KANSAS GAS & ELECTRIC COMPANY
KANSAS CITY POWER AND LIGHT COMPANY
KANSAS ELECTRIC POWER COOPERATIVE, INC.
WOLF CREEK GENERATING STATION
DOCKET NO. 50-482
AMENDMENT TO FACILITY OPERATING LICENSE

Amendment No. 17
License No. NPF-42

ATTACHMENT TO LICENSE AMENDMENT NO. 17

Figure 6.2-1 Operating Corporation Organization

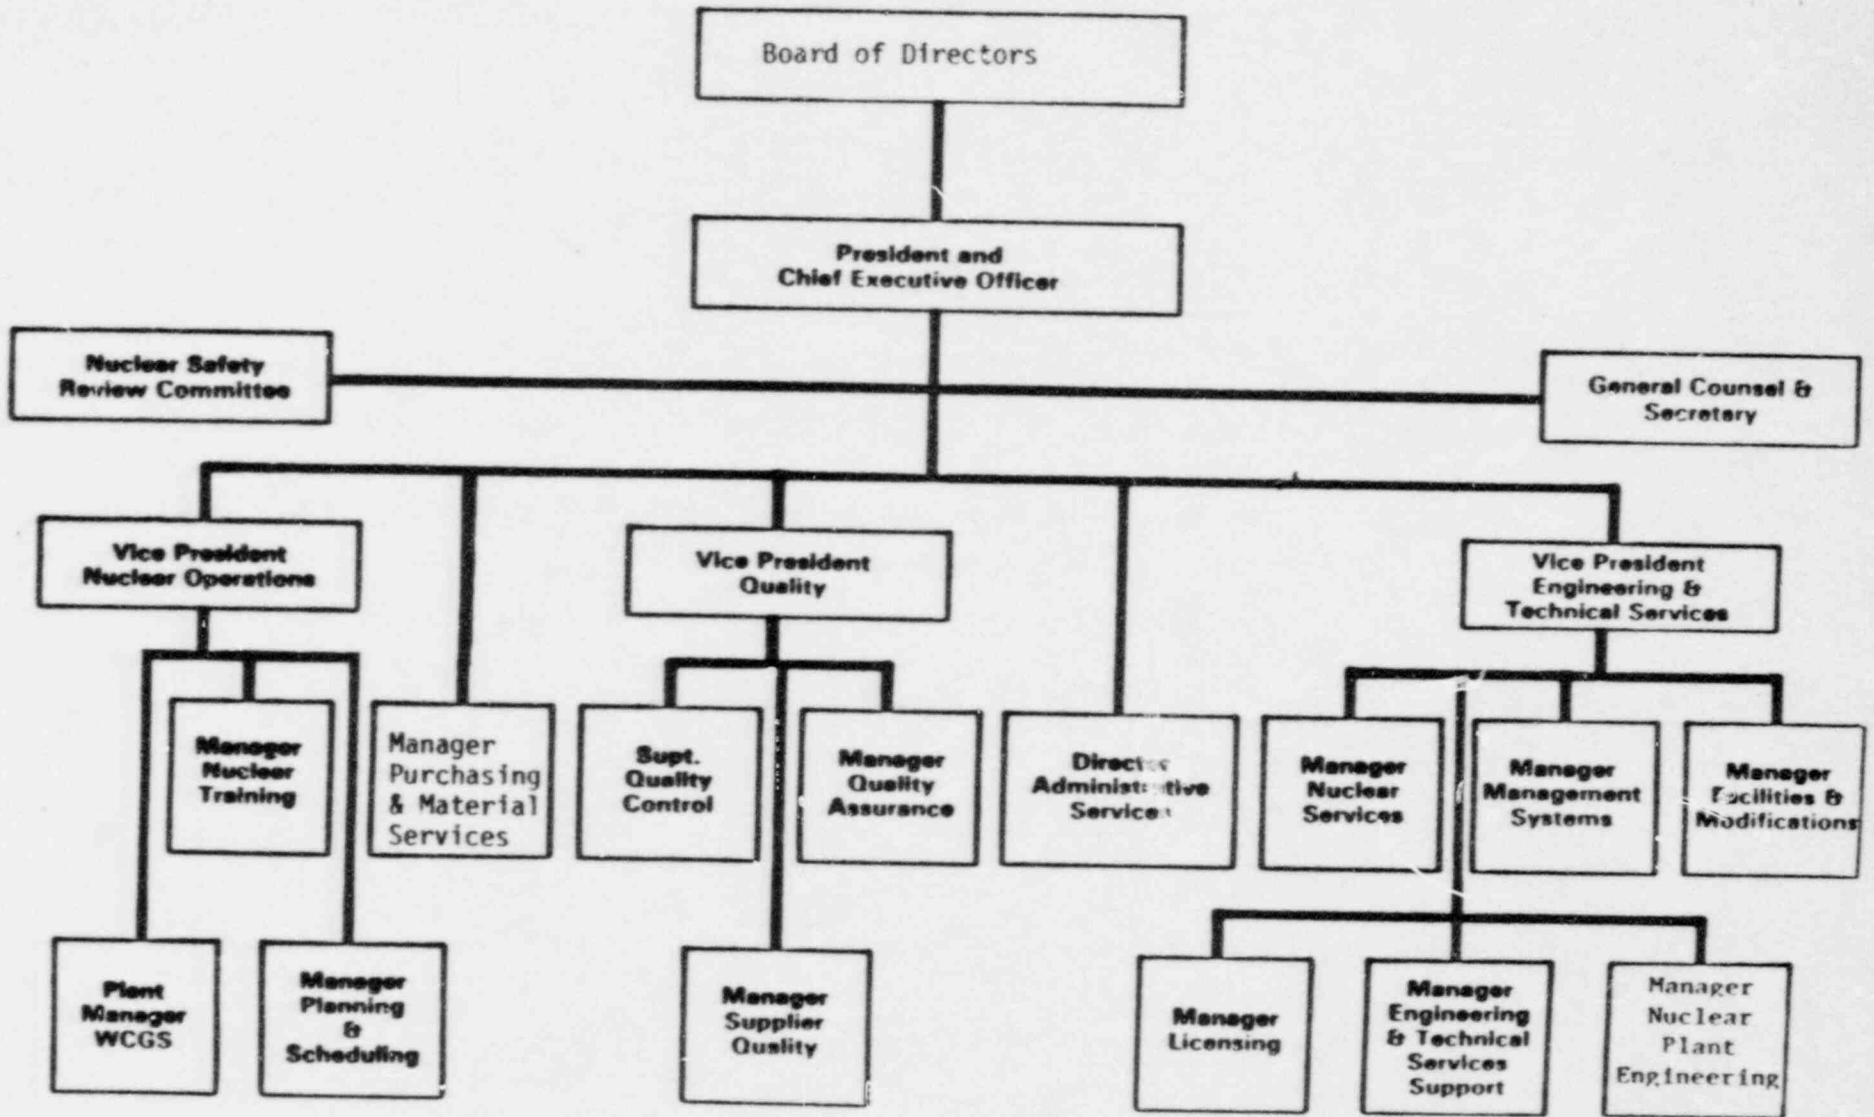
Revise Appendix A Technical Specifications by removing the page identified below and inserting the enclosed pages. The revised page is identified by amendment number and contain marginal lines indicating the area of change.
